TRANS/WP.29/GRRF/2005/8
19 November 2004

World Forum for Harmonization of Vehicle Regulations (WP.29)

AMENDMENT PROPOSAL TO REGULATION No. 13

Transmitted by the expert from the European Association of Automotive Suppliers (CLEPA)

Diagram 1"

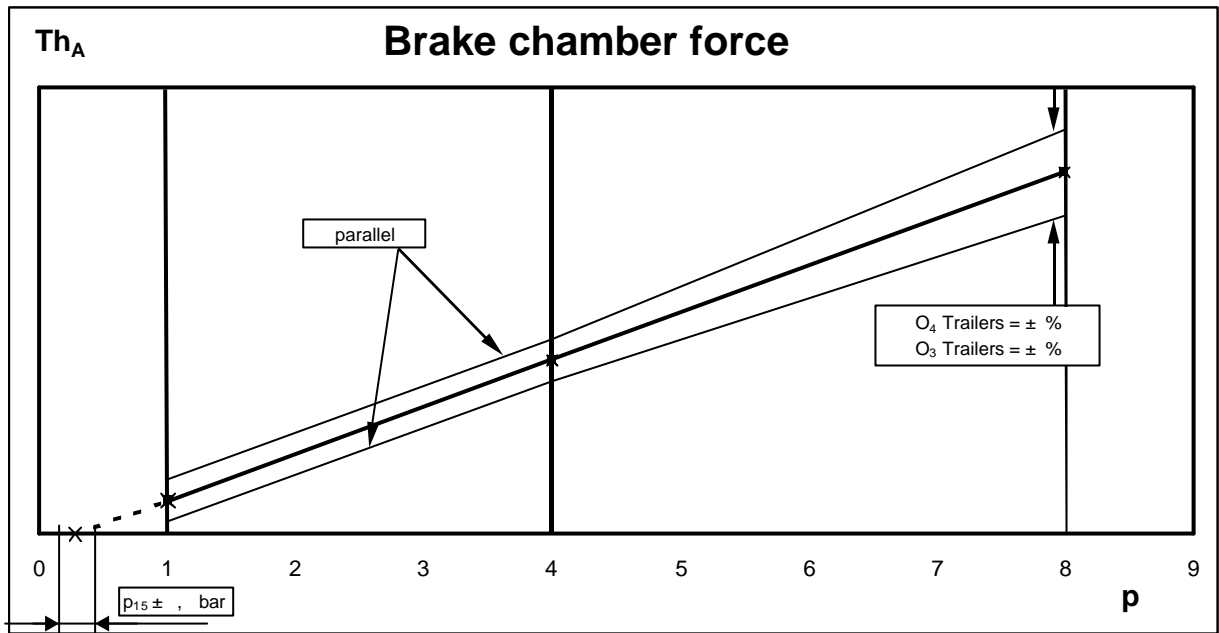
2.3.2. With respect to the verification of average thrust (Th_A) - $f(p)$, a graph defining the acceptable performance variation shall be constructed following the model shown in Diagram 1, which is based on the manufacturers declared thrust to pressure relationship. The manufacturer shall also define the category of trailer for which the brake chamber may be used and the corresponding tolerance band applied."

To overcome this problem, it is proposed that the tolerance band applied to the manufacturers declared performance is constructed in a way that at pressures ≥ 4.0 bar the current +/- 4 per cent tolerance remains unchanged. The tolerance band from 4.0 bar to 1 bar would then be parallel based on the force difference determined at 4.0 bar. This tolerance band would be applied to brake chambers that may be installed on trailers of category O₄, which generally utilize the larger size of brake chamber. In the case of O₃ trailers, where the use of smaller brake chambers is common, a larger tolerance is required. In this case, it is proposed that the above defined tolerance band has a tolerance of +/- 6 per cent.
